UNITED STATES ENVIRONMENTAL
PROTECTION AGENCY
REGION IX
75 Hawthorne Street
San Francisco, CA 94105

March 16, 2020

Re: Response to Corrosion and Metal Fatigue Practices, Destructive Testing Results Report, Red Hill Bulk Fuel Storage Facility (Red Hill), Joint Base Pearl Harbor-Hickam, Oahu, Hawaii

Corrosion Report on Red Hill Bulk Fuel Storage Facility

Figure 5 – Destructive Testing Cross-section from Sample 3-3.

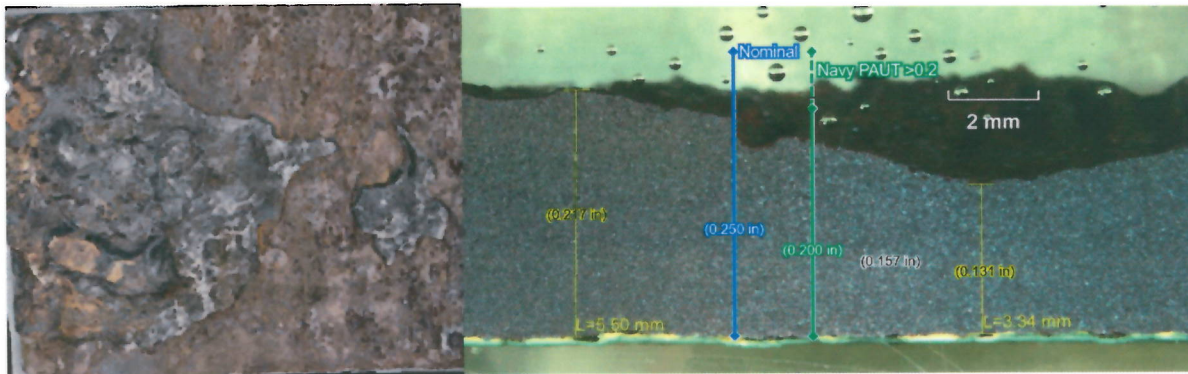
A more graphic illustration of the error in the NDE methodology is shown in Figure 5. The image on the left-hand side of Figure 5 shows the extensive backside corrosion on Coupon 3. The right-hand side of Figure 5 shows the plate's reported thinnest area in cross-section after destructively testing. While it is unclear from the DT and IMR reports, this thinned region

(0.131-inch-thick) was presumably located by CT scanning of the entire coupon. The Navy NDE predicted that this area had little to no backside corrosion.

The thin blue-green layer on the bottom of the plate on the right-hand side of Figure 5 is the paint on the fuel wetted side of the steel liner. The blue line shows the full plate thickness of 0.250 inches. The yellow line on the left side is the actual maximum plate thickness which shows 0.217 inches thickness indicating general corrosion thinning and deeper corrosion over the back side of this steel coupon. The green line shows the thickness the PAUT found, i.e., > 0.200 inches (LFET found a remaining wall of 0.033 inches but the supposedly more accurate PAUT indicated the plate was much thicker). The actual minimum thickness found by DT was 0.131-inches as shown by the yellow line on the right side. This variation in the lengths of the colored lines illustrates how large the difference can be between the various NDE inspection techniques and the actual depth of corrosion. In this case, LFET indicated the plate was very thin, the PAUT prove-up indicated little-to-no corrosion, and the DT indicated that this location was sufficiently thinned that repair should have been triggered.

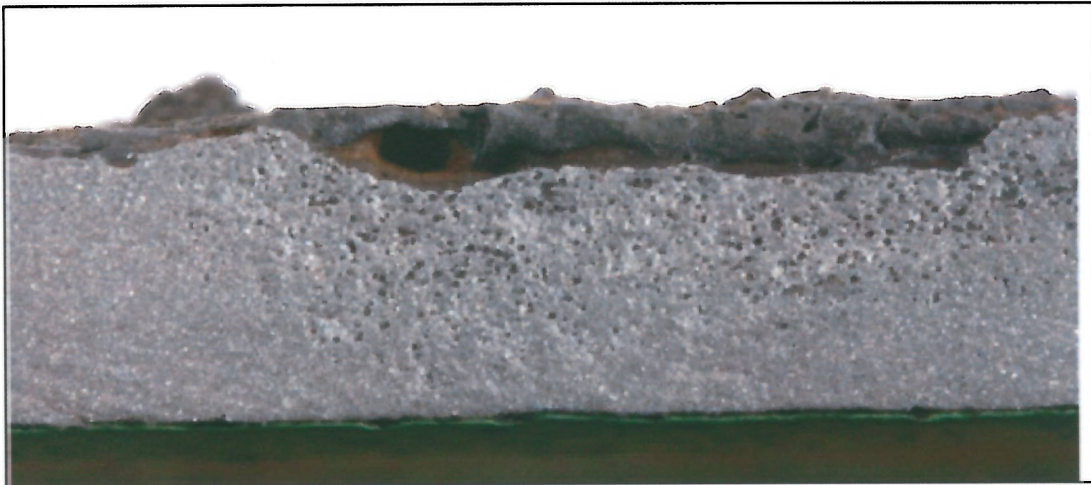
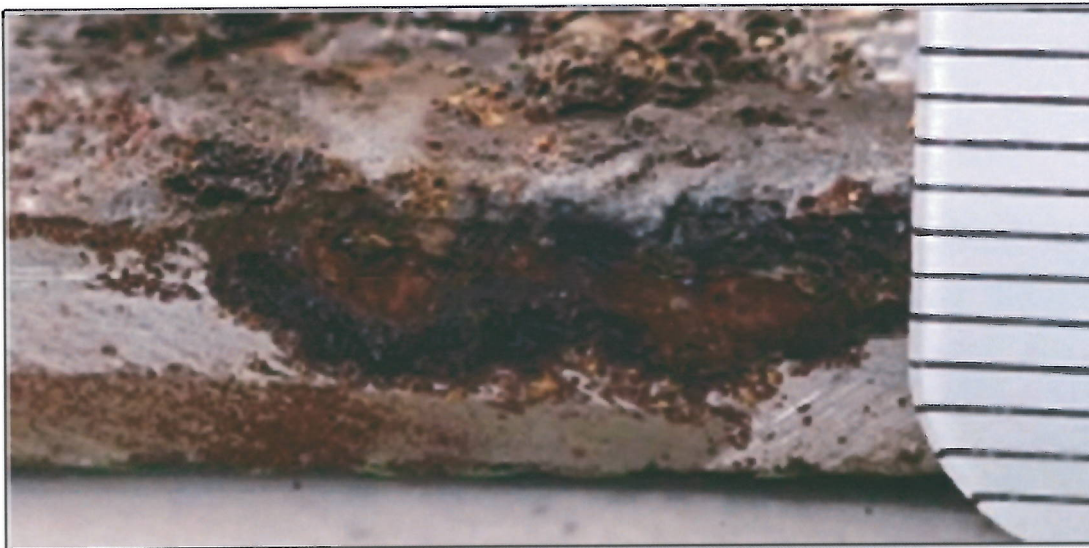
BWS disagrees:

1. There was pitting observed as shown in their Figure A-4
2. It is not surprising that corrosion was not found as this area had been sandblasted.
3. The explanation that the area of concern "had been superficially altered by heat associated with sectioning or some other post-sectioning reaction (atmospheric corrosion or corrosive media attack)" is not credible. Atmospheric corrosion would be uniformly distributed along the cut surface, but the area of concern is localized. Secondly, the porosity is not consistent with heat associated with sectioning. Finally, we are unaware of any corrosive media used during coupon removal that could have locally attacked the edge in the area of concern.
